SUBJECT: PALO VERDE NUCLEAR GENERATING STATION, UNIT 1 - REVIEW OF
STEAM GENERATOR TUBE INSPECTION SUMMARY REPORT
(TAC NO. MC7368)

REVIEW OF THE 2002 AND 2004 STEAM GENERATOR TUBE INSPECTION REPORTS

PALO VERDE NUCLEAR GENERATING STATION, UNIT 1

**Arizona Public Service (APS)
Response to the Staff's Request for Additional Information**

SG - 11 ARC REGION WITH AXIAL INDICATIONS

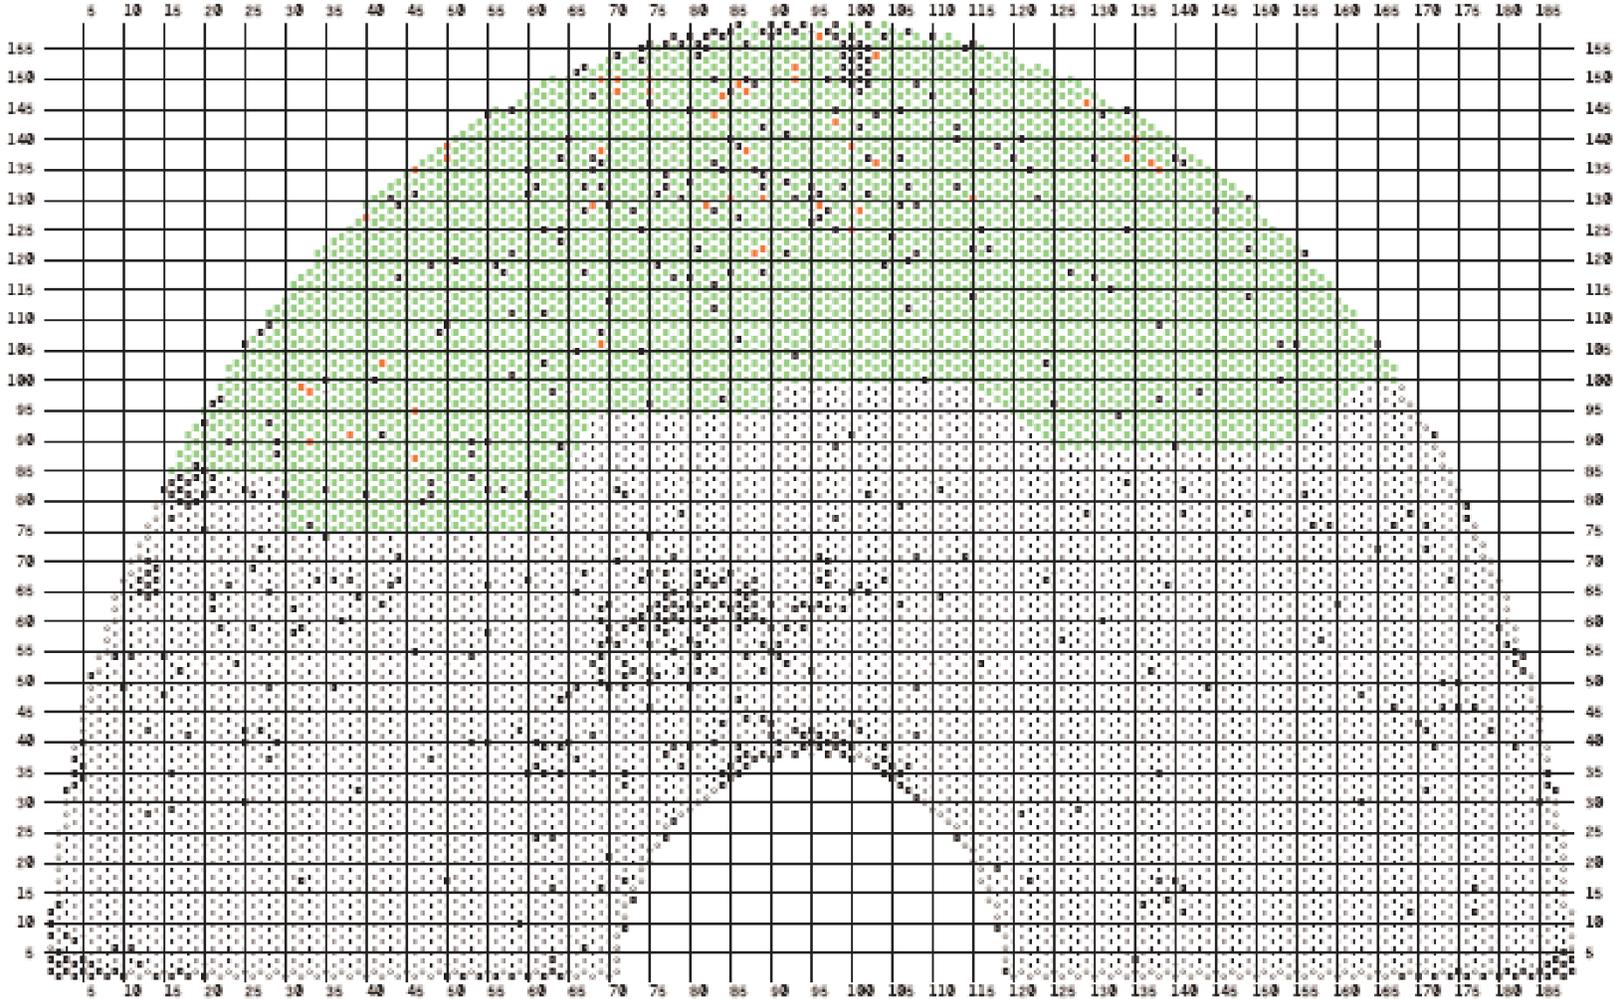
Please clarify the scope of your rotating probe inspections of wear scars during your Unit 1 2004 (U1R11) inspections. The staff notes that your response to Generic Letter 2004-01 indicates that you perform rotating probe inspections of all previous wear calls and all new bobbin indications. However, Table 1 of your April 18, 2005, letter indicates far fewer rotating probe inspections of previous and current bobbin indications than the number of wear indications reported in Table 2. Is this a result of reporting the number of tubes in Table 1 and the number of indications in Table 2. Could this also be a result of some of the wear scars being examined as part of other examinations (e.g., rotating probe exams in the ARC)?

All bobbin wear indications, both new and previously called, are rotating pancake coil (RPC) examined. A significant number of wear indications are within the Palo Verde ARC location (See attached Tubesheet Maps for discussion purposes). These bobbin indications are, therefore, included in the ARC RPC examinations and not scheduled separately.
